X 95.004-26

23 LC

Connecting rod

J *compl 530 01 40-16

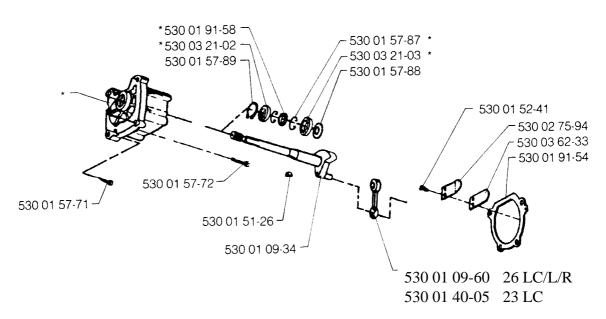
In the spare parts list for 23/26LC/L/R 1.1993 no 106 23 37-63 the wrong ref. no. for the connecting road is stated.

The connecting rod in box J has the ref. no. 530 01 09-60. This number only applies to 26 LC/L/R.

The connecting rod for 23 LC should have the ref. no. 530 01 40-05.
